To be held on Monday, December 14, 2015 at **2:30 p.m.** Committee Members are asked to meet in the **Council Chambers** at 395 Mulock Drive, Newmarket, Ontario.

1. **APPLICATION FOR AMENDMENT TO SITE PLAN APPROVAL** p. 1
120 BAYVIEW PARKWAY – WARD 3
(NORTH OF DAVIS DRIVE, WEST SIDE OF BAYVIEW PARKWAY)
OUR FILE NO.: D14-NP1521
LAKE SIMCOE REGION CONSERVATION AUTHORITY

2. **APPLICATION FOR SITE PLAN APPROVAL**
445 HARRY WALKER PARKWAY SOUTH – WARD 2
(NORTH OF MULOCK DRIVE, EAST SIDE OF HARRY WALKER PKWY. S.)
OUR FILE NO.: D14-NP1522
THE REGIONAL MUNICIPALITY OF YORK

SITE PLAN
PROPOSED

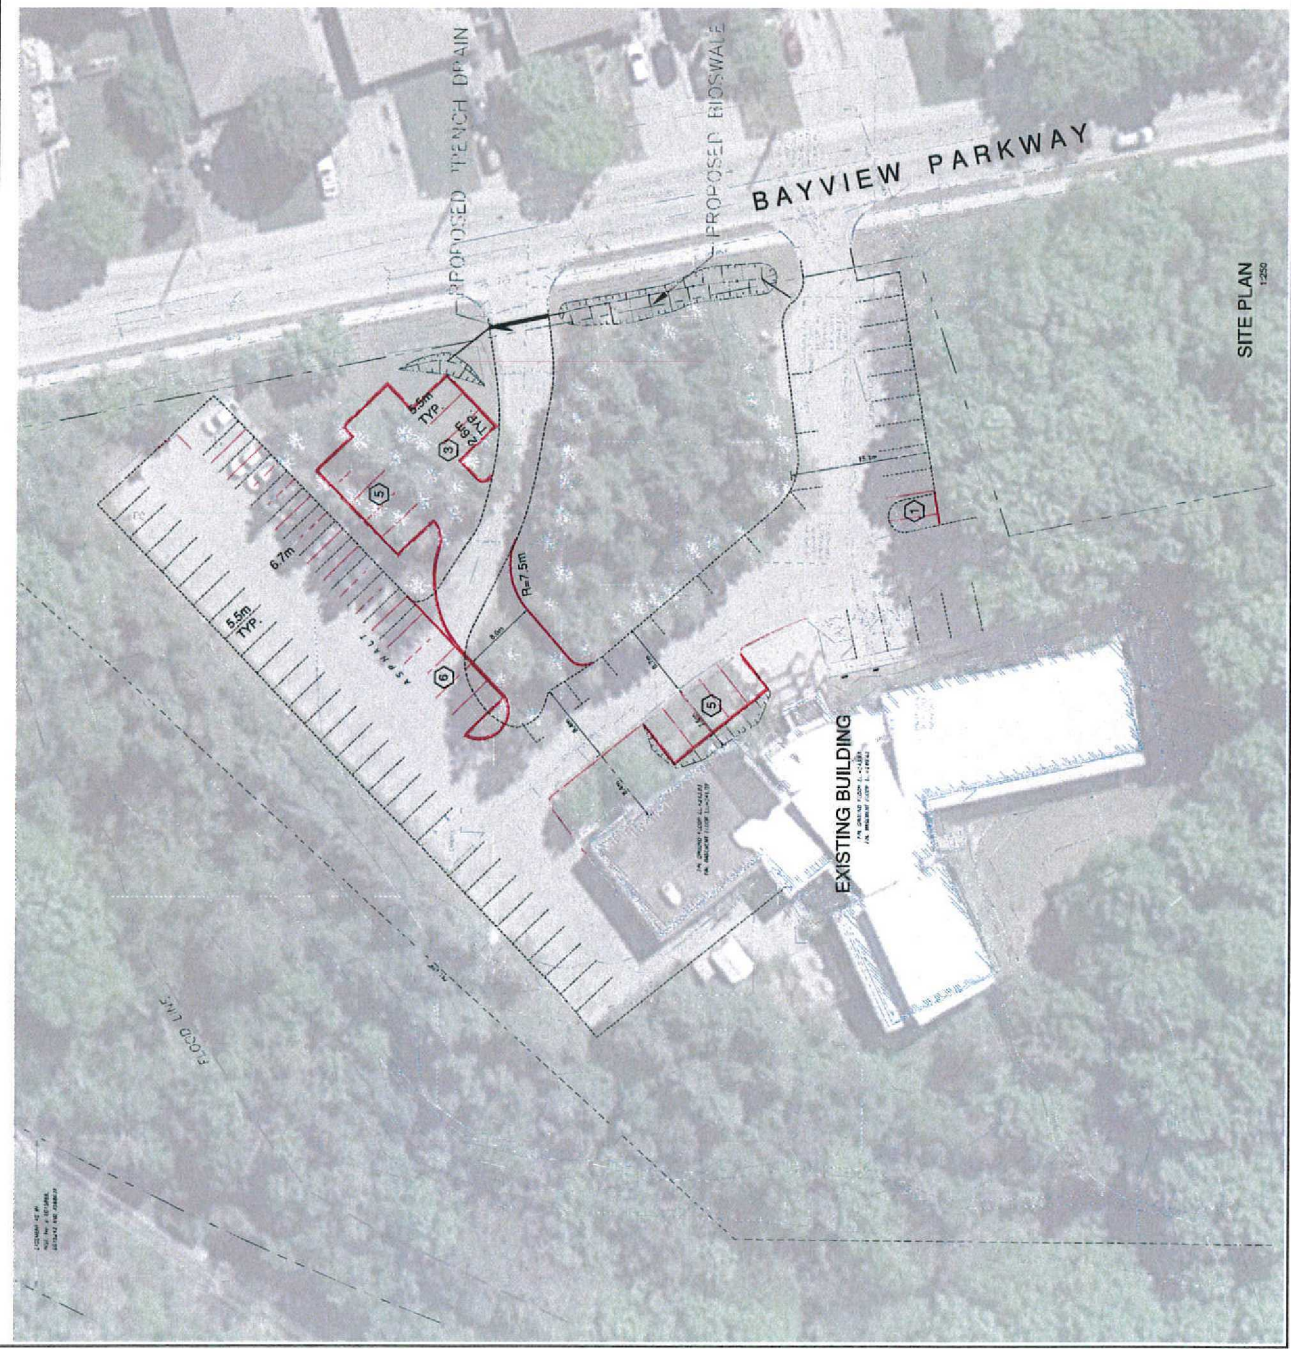
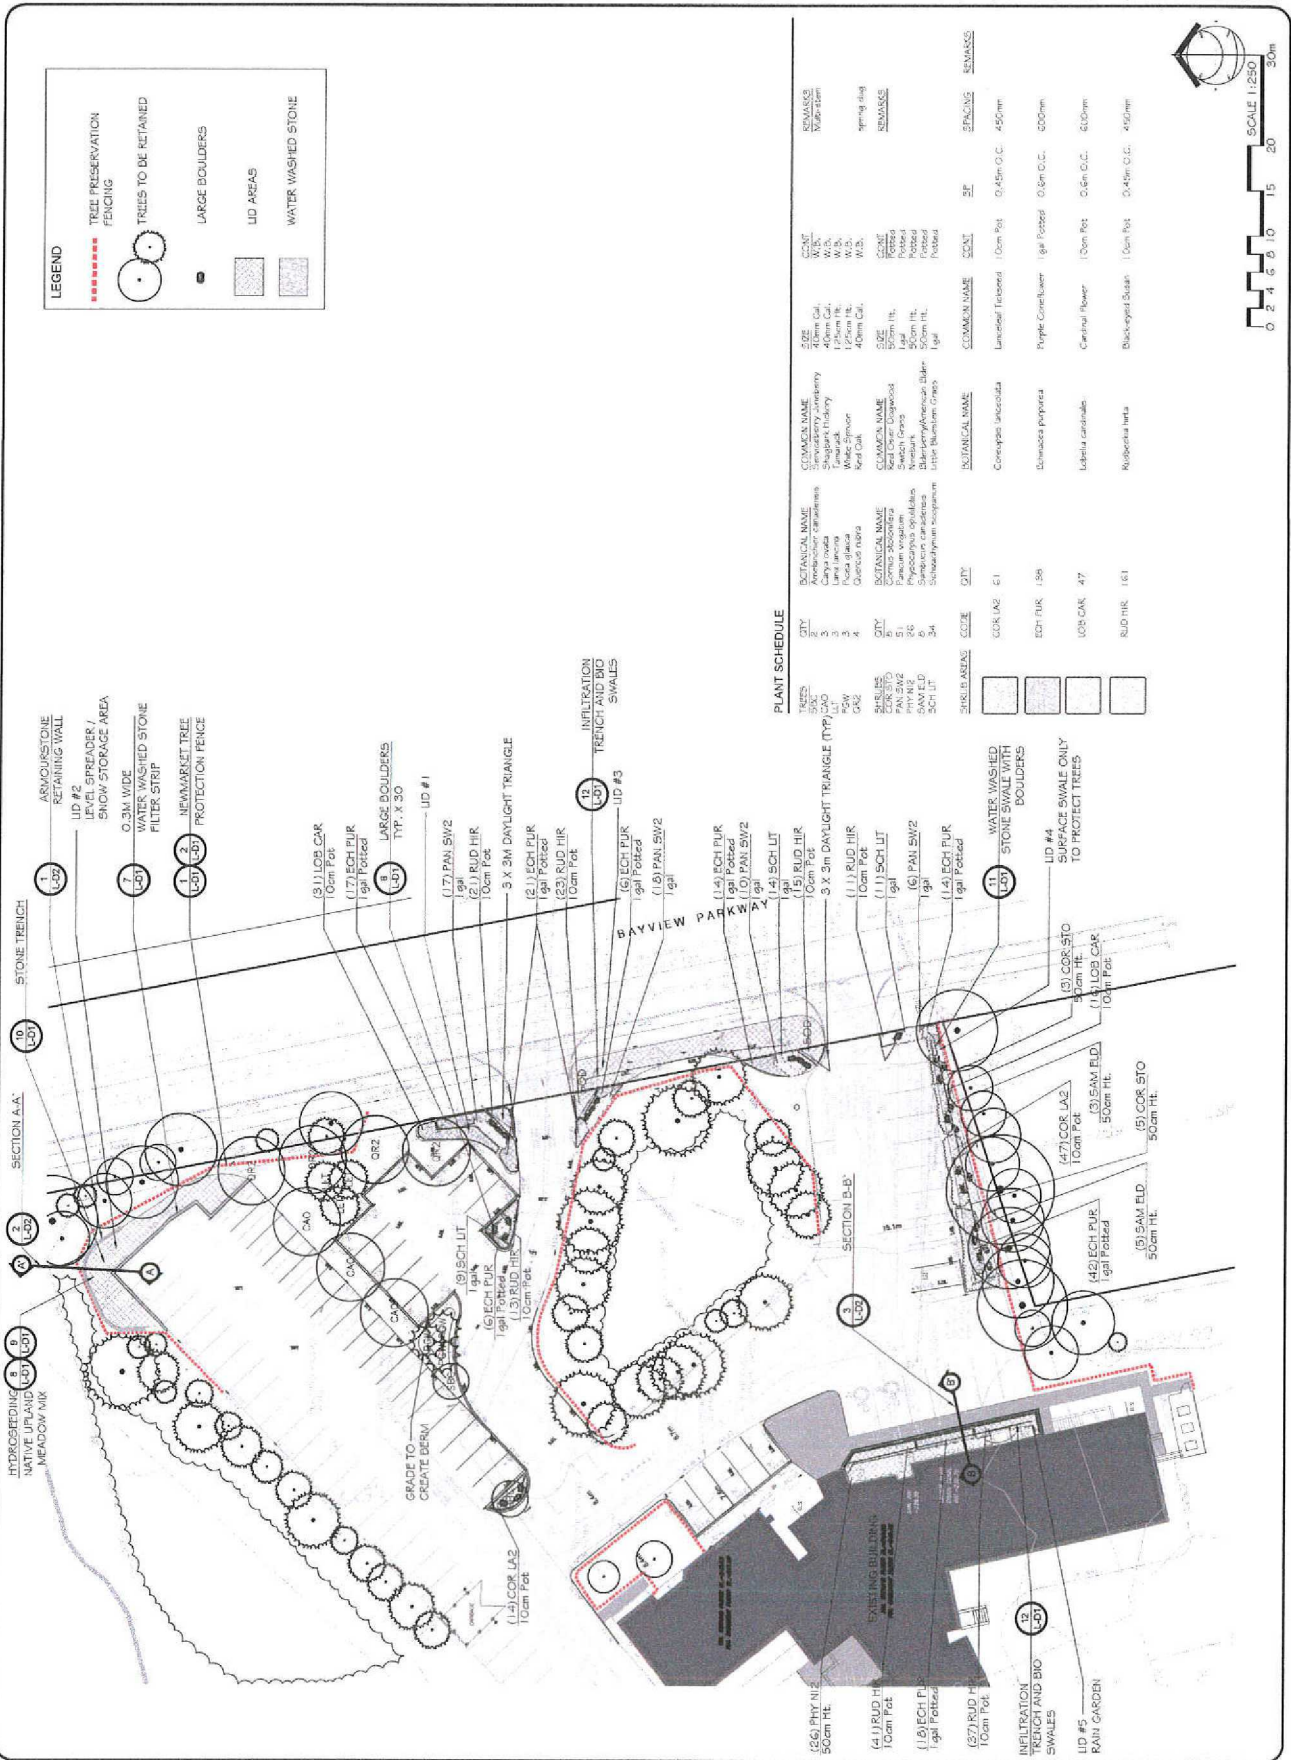
- Arborist Report and Tree Preservation and Removal Plan to be peer reviewed by Town's Consulting Arborist
- Environmental Impact Study required; study will be peer reviewed
- Property is within Wellhead Protection Area (WHPA-D) – applicant to obtain Section 59 Notice from Region of York
- Consideration to be given to installation of pedestrian walkway from sidewalk to building
- Construction Management Plan required prior to work commencing
- Public Information Centre to be held unless Committee directs otherwise

RENDERINGS

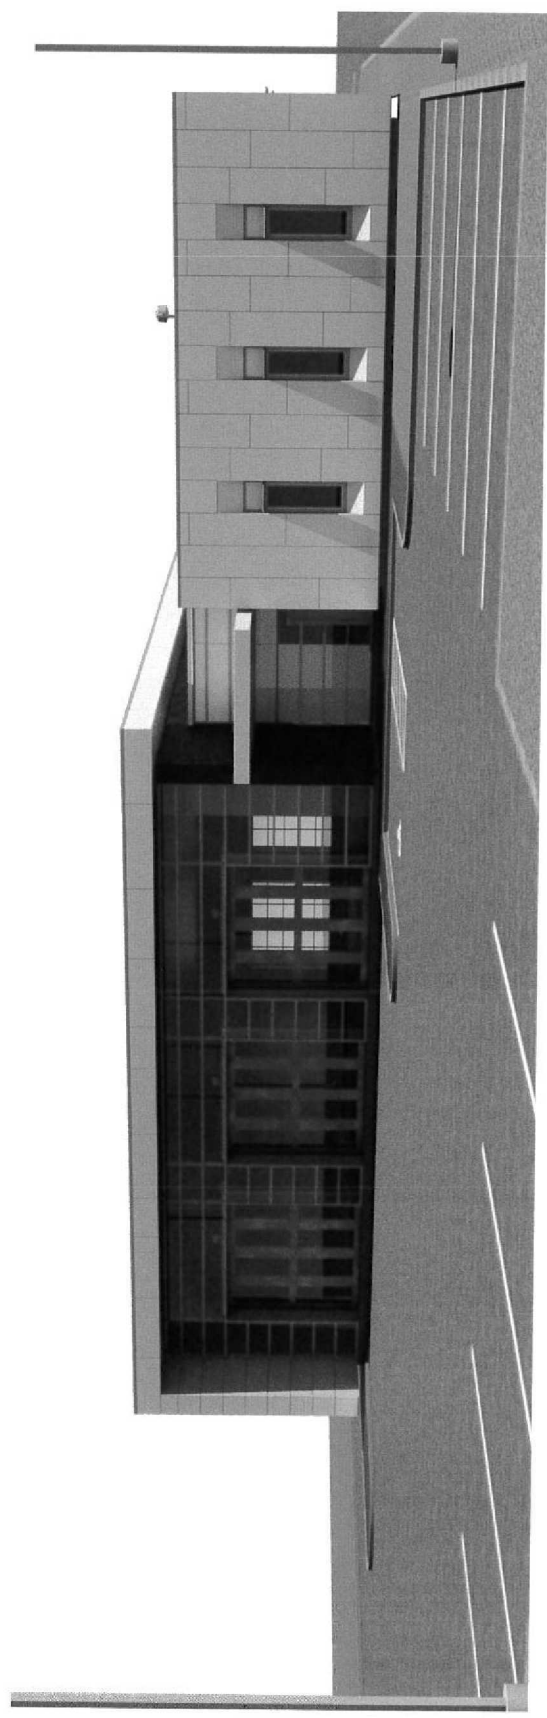
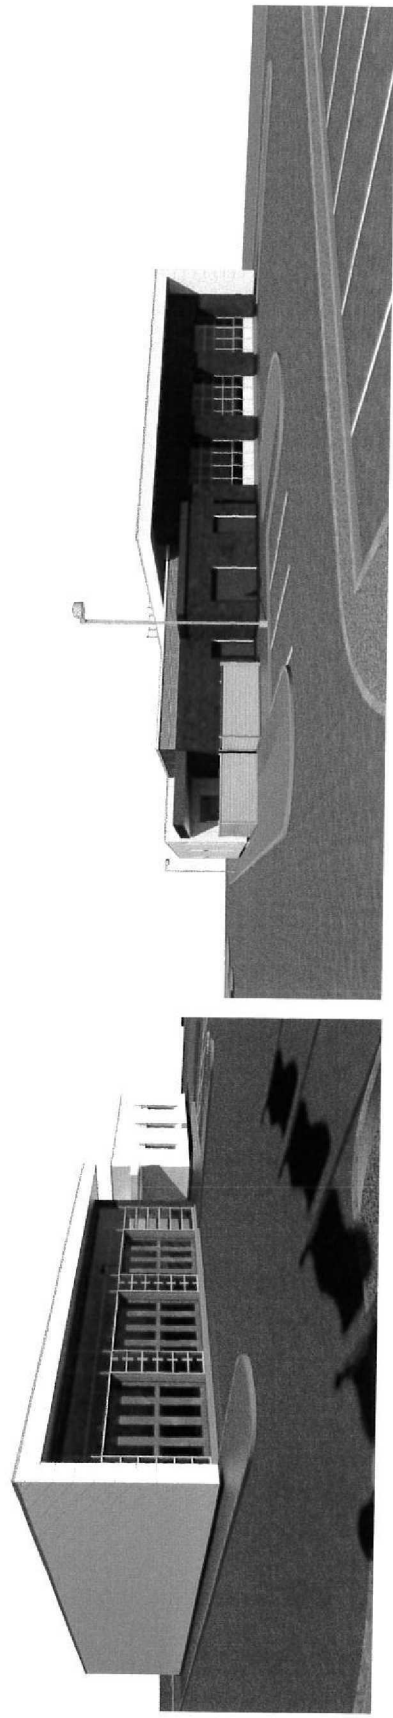
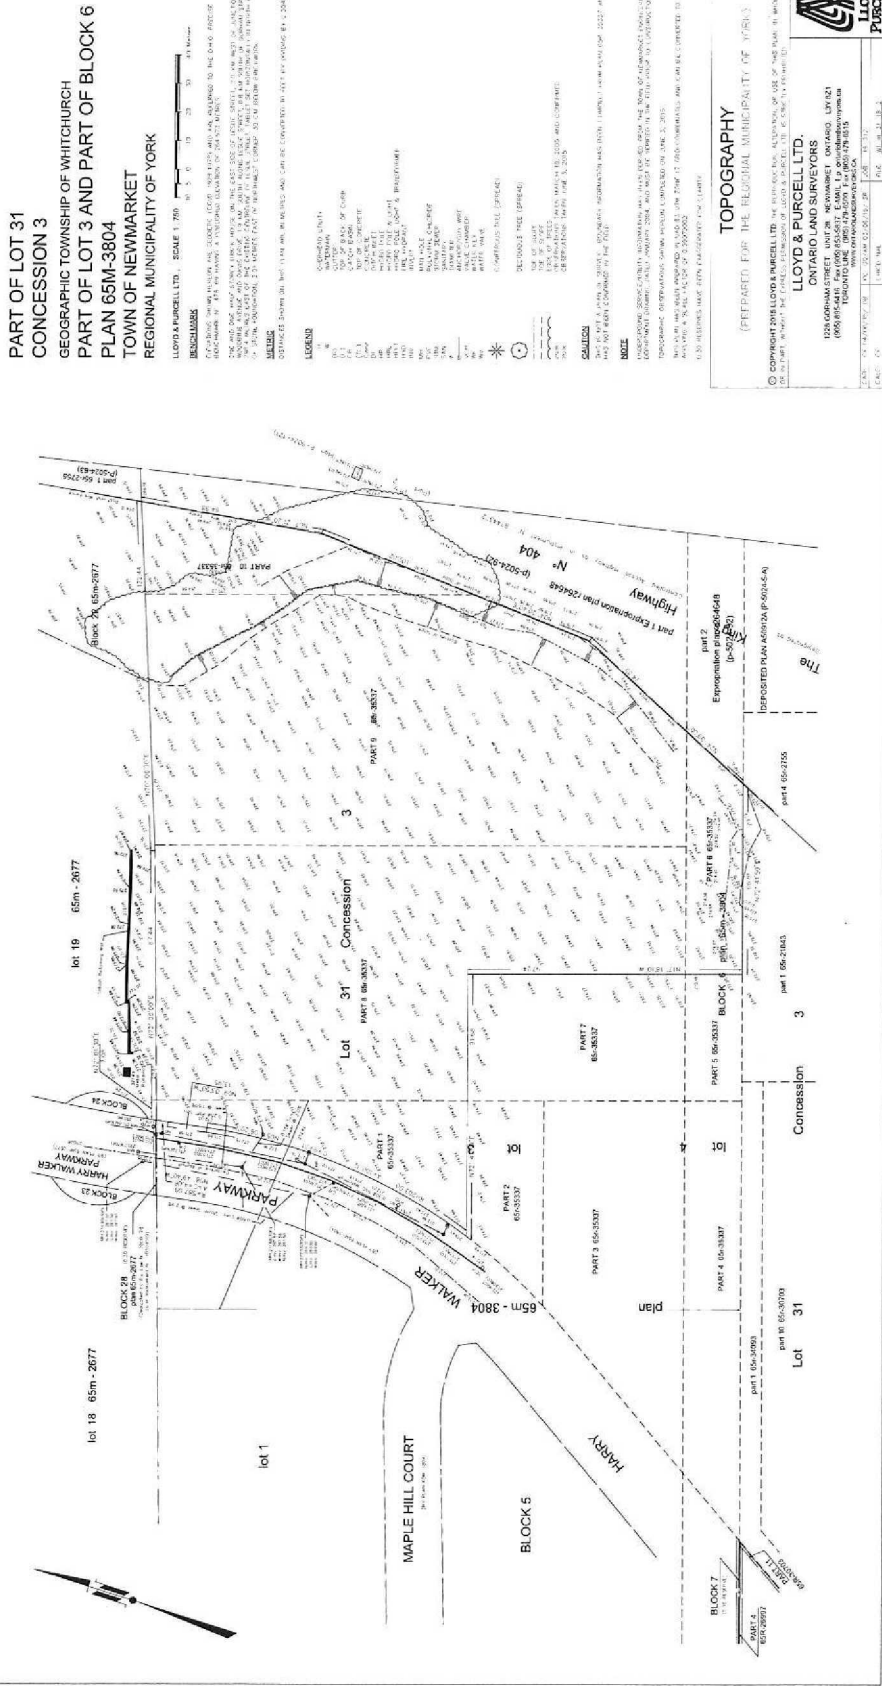
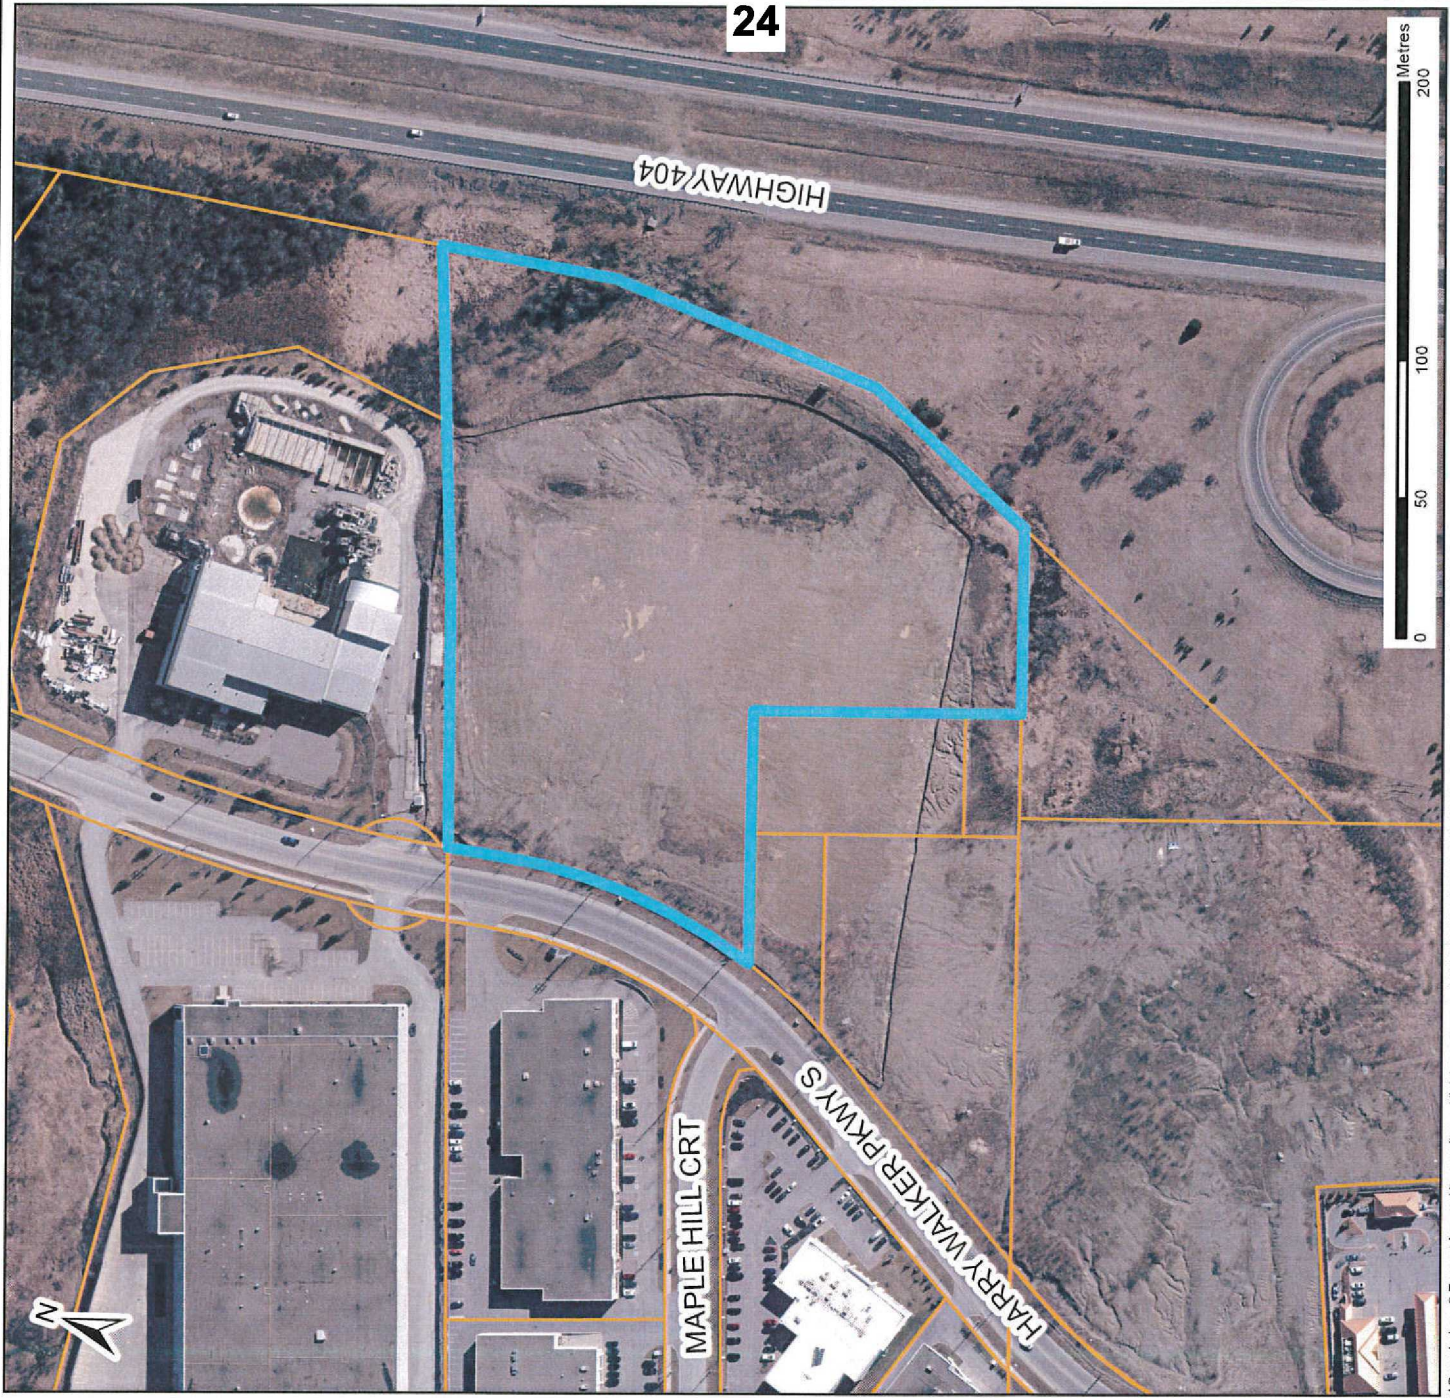
- Parking spaces along northerly property line do not meet setback requirements
- Drawings to be revised to be consistent with each other
- Additional landscaping to be provided
- Consideration to be given to installation of pedestrian walkway through site to front door
- Arborist Report and Tree Preservation Plan to be peer reviewed by Town's Consulting Arborist
- Construction Management Plan required prior to work commencing
- Public Information Centre to be held unless Committee directs otherwise
- Permit may be required from Ministry of Transportation
